**PROJECT: No 2, BALLYROAN LODGE,**

**DOCUMENT TITLE: FURTHER INFORMATION REQUEST REPORT**

**DOCUMENT NO: 21.277– RP – 01**

**NO 2, BALLYROAN LODGE,  
BALLYROAN, DUBLIN 16**

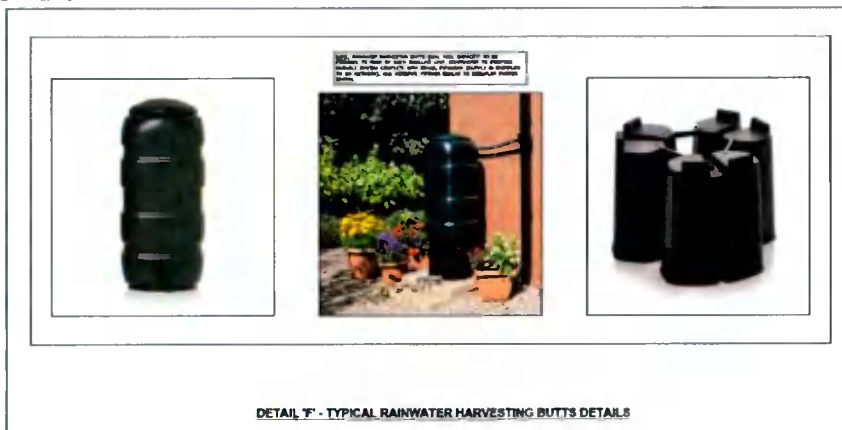
- "The applicant has shown the surface water runoff from the proposed development to be connected into the foul water drainage network. This is not acceptable as foul and surface water drainage systems must be designed to discharge to separate pipe networks. The applicant is requested to submit a revised surface and foul water drainage layout drawing for the proposed development clearly showing that the foul and surface water drainage systems are discharging to separate pipe networks and to investigate the potential to incorporate a soakaway on site to separate the surface and foul water drainage systems. The applicant is required to submit a report showing site specific soil percolation test results and design calculations for a proposed soakaway in accordance with BRE Digest 365 – Soakaway Design"***

**BMCE:** The Foul and Surface water layouts has been revised and the surface water will be connected to a discharge manhole, before connecting into the combined foul network. There is no existing surface water infrastructure in the access road. The surface water will be collected

separately and be connected to a discharge manhole, before connecting to the combined sewer. The discharge manhole will be installed to cater for the future installation of a surface water network. The surface water can then be connected to the public network if the council upgrades the network in the laneway.
